# **Equinix DB8 Elevation Studies October 2021**

Options considered in response to Local Authority Further Information Request

Issued to SDCC for review on 13 October 2021

# Design Development

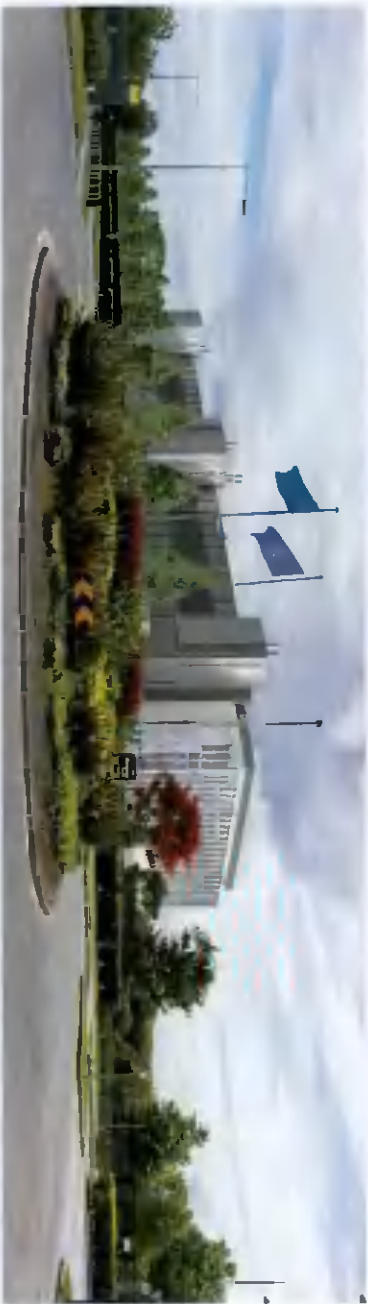
which led to the Preferred Option
